MEMORANDUM

DATE: March 1, 2024

RE: Greenburgh Hebrew Center

Greenburgh Hebrew Center (the “Applicant” and “Owner”) is seeking Site Plan approval construct a new playground and complete various improvements to the existing parking lot and associated driveways and sidewalks on the lot. The property is located at 515 Broadway, Section Block and Lot 3.40-4-11 (“Project Site”) and is located in the OF-1, One Family Residential 1, zoning district.

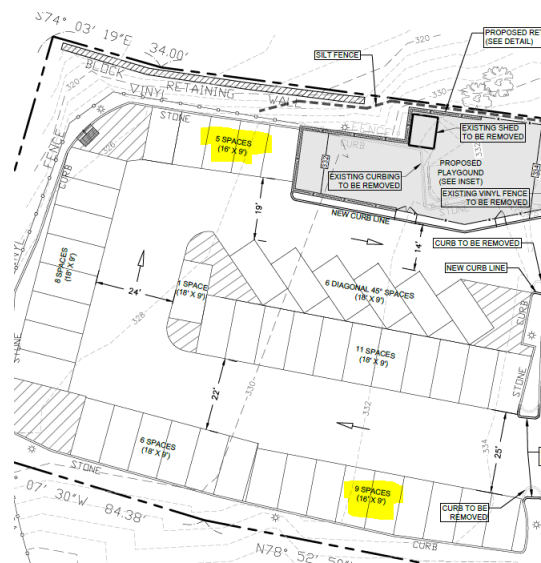
- a. The use of the house of worship is an existing nonconforming use. A similar application was seen before the Planning Board in 1992, at which point the Board waived site plan review allowing for a proposed playground area. The Board at that point had clarified that the playground was solely for the use of the Greenburgh Hebrew Center. It appears that the applicant did complete the work associated with the previous proposal. See GoogleEarth snip below.

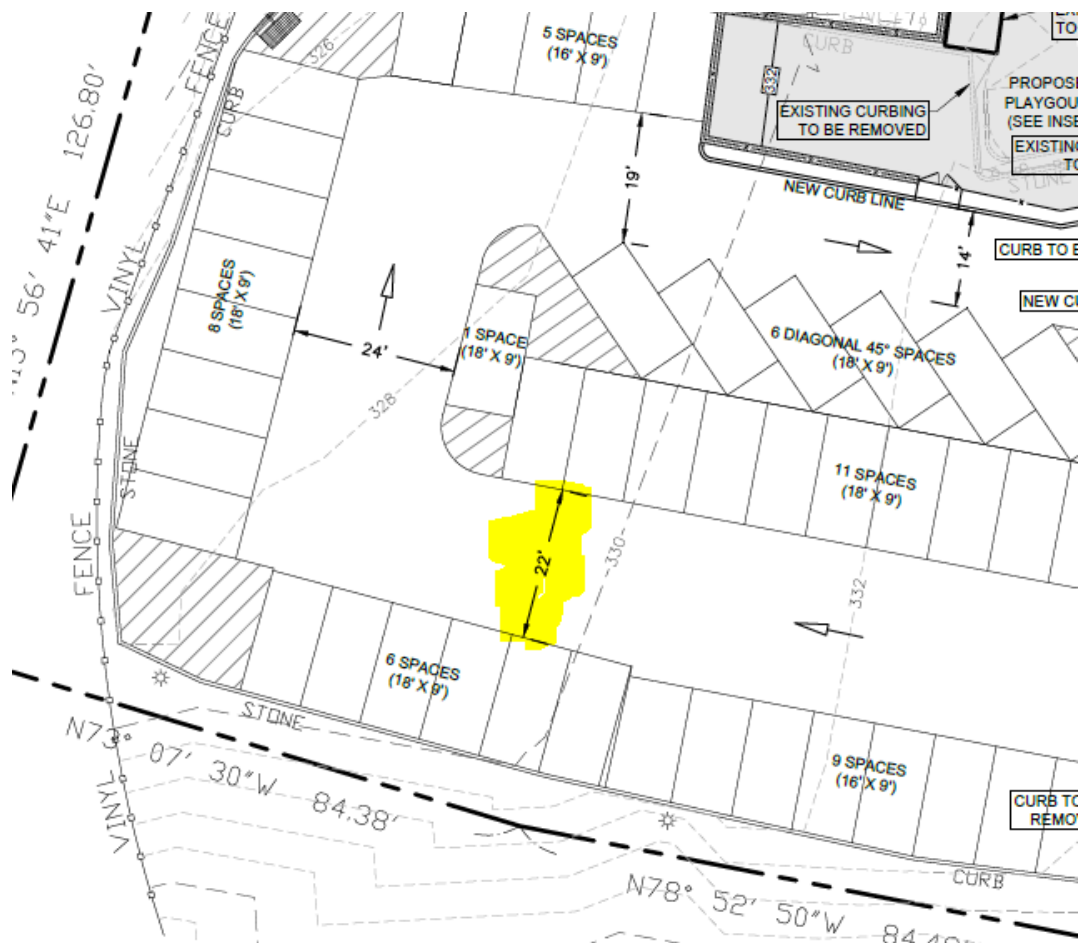
- *Parking dimensions. Each off-street parking space for nonresidential use shall measure a minimum of nine feet in width by 18 feet in length. Each off-street parking space for residential use shall measure a minimum of eight feet six inches in width by 18 feet in length. Accessible parking spaces shall meet standards of the Americans with Disabilities Act. **The applicant appears to be proposing 14 noncompliant spaces. See the highlighted spots below.***

The western portion of the southern aisle does not appear to be compliant with this requirement. See the highlighted location below.
